U.S. Department of  
Transportation  
Federal Highway  
Administration

March 3, 2000

Refer to: HSA-1

Thank you for your letter of November 8, 1999, requesting Federal Highway Administration (FHWA) acceptance of a number of your company's portable sign stands as a crashworthy traffic control devices for use in work zones on the National Highway System (NHS). Accompanying your letter was a copy of the crash test report by Safety Quest, Inc., and video documentation of the crash tests. You requested that we find the three tested devices, as well as certain devices of similar design, acceptable for use on the National Highway System under the provisions of National Cooperative Highway Research Program Report 350 "Recommended Procedures for the Safety Performance Evaluation of Highway Features." You provided additional information on January 18, 2000, regarding specific product requests.

NAME: MODEL 4814 CS

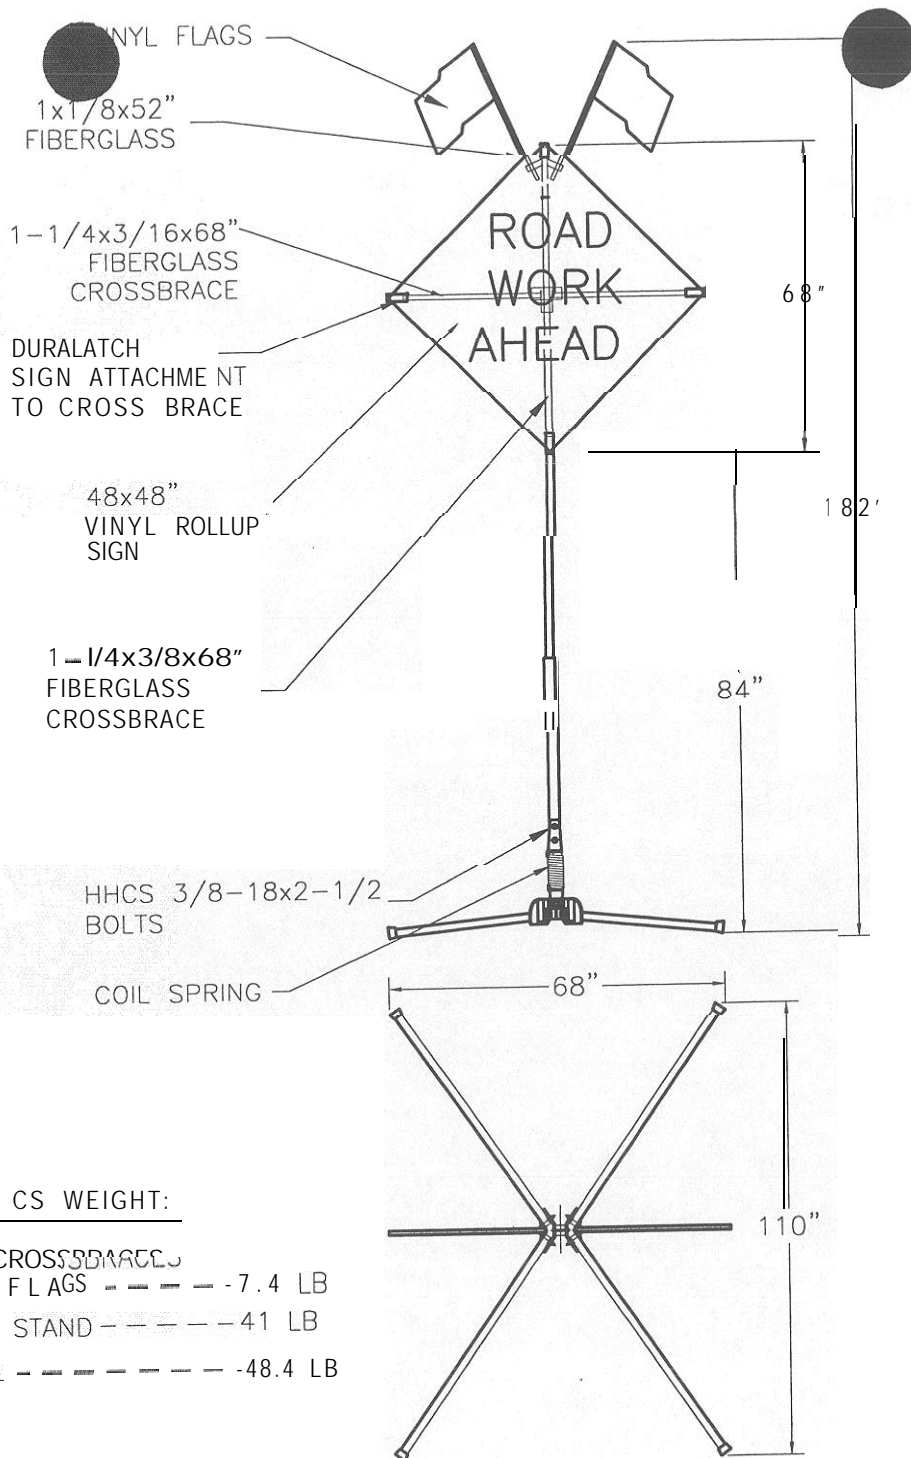
All stands have square aluminum legs and aluminum upright masts and were tested with 1219 x 1219-mm roll-up signs. All signs were affixed with warning flags on either fiberglass staffs or wood dowels. The tested stands were: MDI 4814 CS Compact Sign Stand. This is a dual vertical spring mounted support for roll-up signs. The legs telescope to a maximum spread of 1800-mm (71 inches) in the direction of traffic, and the upright mast is 1260-mm (49.5 inches) high. It was tested with a sign mounted 368-mm (14 inches) from the pavement to the bottom of the sign.

Model 4814CS was tested at 0 and 90 degrees. This stand has an aluminum up to a point in the middle of the roll-up sign bracing.

It carries a sign mounted at 370-mm. You requested acceptance for model 4815 which only differs in the length of the legs and in the specific method of attaching the sign to the stand. We concur that the performance of the Model 48 15 stand would be comparable to the 4814 CS.

In summary, the stands we find acceptable are the tested 4814 CS, 4884CS, 4860 KA and the ~~similar~~ stands 4850, 4860 with 2.1 m mounting height, 4812, 4818, 4815 and 4814 K as shown in the enclosed drawings.

Date: 03/10/99  
 NAME: MODEL 4884 CS

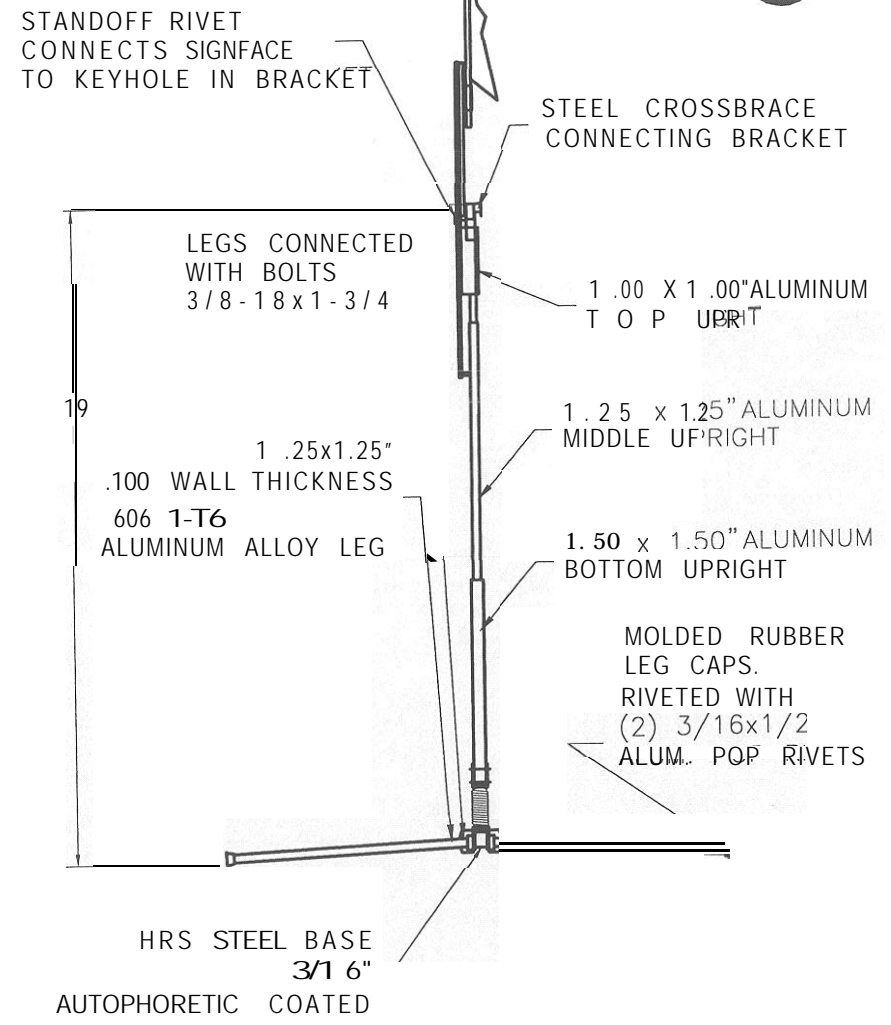
#### MDI 4884 CS Compact Sign Stand

This is a single vertical spring mounted support for roll-up signs. The rigid legs have a maximum spread of 2800-mm (110 inches), and the upright mast extends to a maximum height of 3030-mm (119 inches) to the top of the sign. It was tested with a sign mounted with its lowest point 2134mm (84 inches) above the pavement.

NAME: MODEL 4860 KA

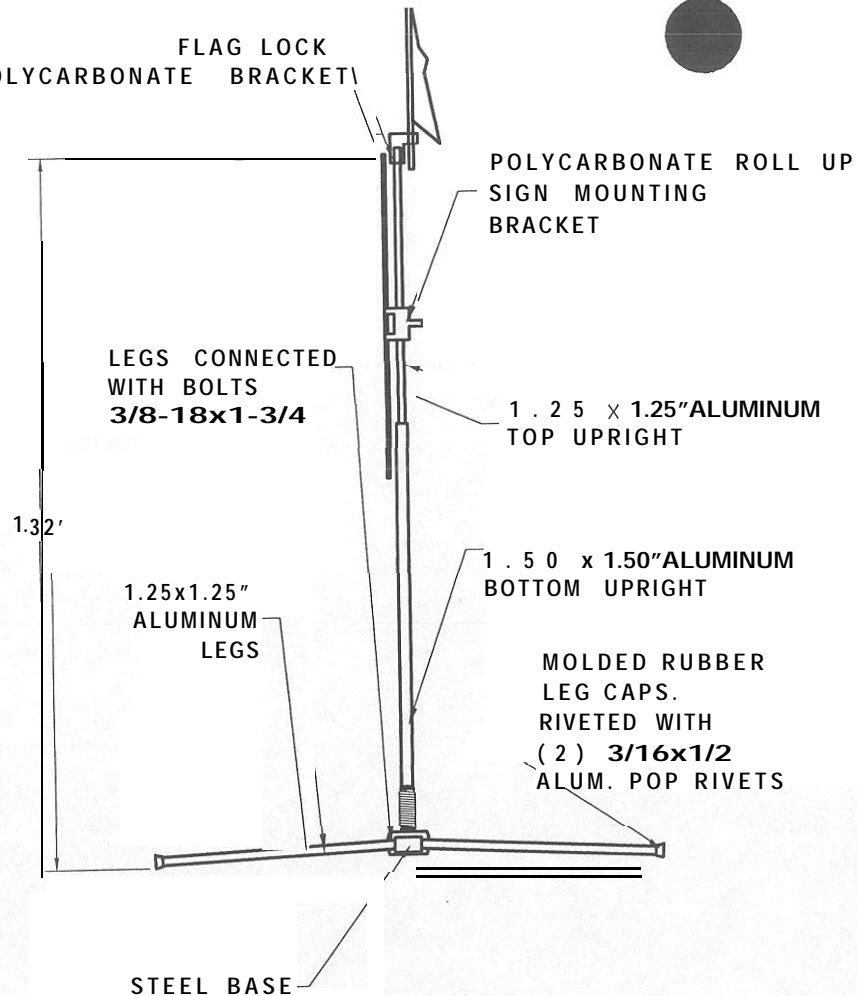
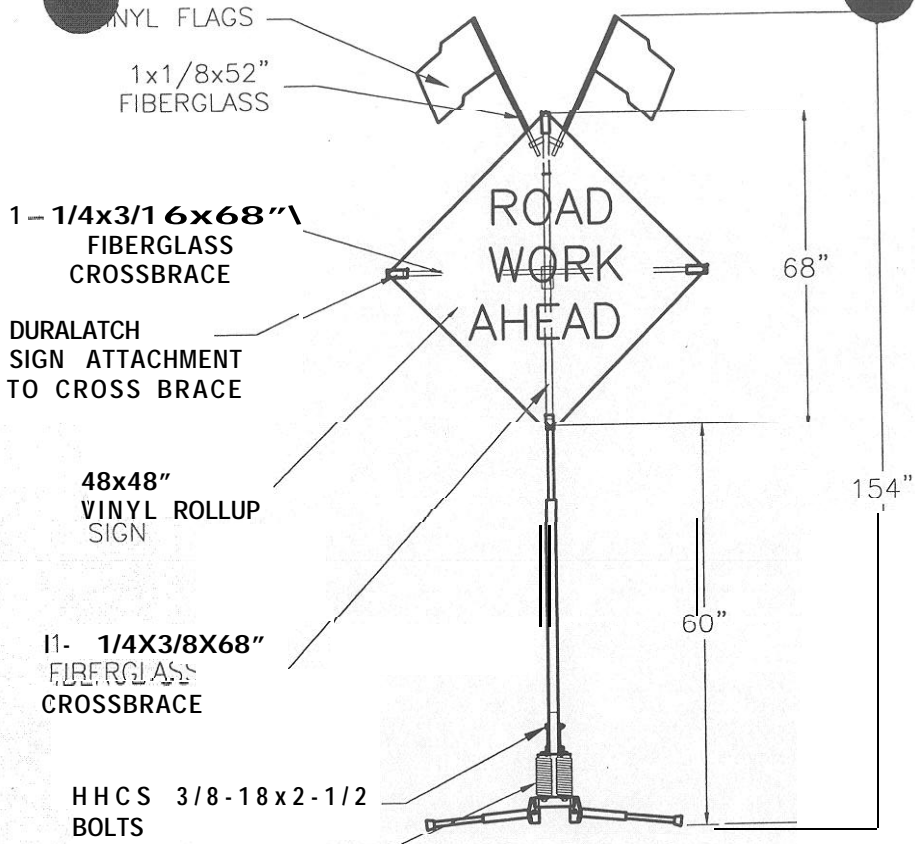
#### MDI 4860 KA

This is a dual vertical spring mounted support for roll-up signs. The rigid legs have a maximum spread of 3124-mm (123 inches), and the upright mast extends to a maximum height of 3350-mm (132 inches) to the top of the sign. It was tested with a sign mounted with its lowest point 1524mm (60 inches) above the pavement.

Model 4860 was tested at 0 and at 90 degrees. This metal-masted support carried a roll-up sign mounted at 1524 mm. You requested acceptance for model 4850 with sign mounted as shown in the enclosed drawing, and model 4860 with sign mounted at 2.1-m (7 feet). Stand 4850 is comparable in design to the tested 4860, and holds the sign at the same height.

Although there are some differences in the layout of the legs and the manner in which the sign attaches to the stand we concur that performance would be similar. Stand 4860 was tested at 1524-m and we concur that the same stand would perform acceptably at 2.1-m because of the greater likelihood that the test article would go over the vehicle without further damage. Stand models 4.3 18 and 18 12 have similar bases and mast structure but do not hold the sign as high as the tested Model 4860.
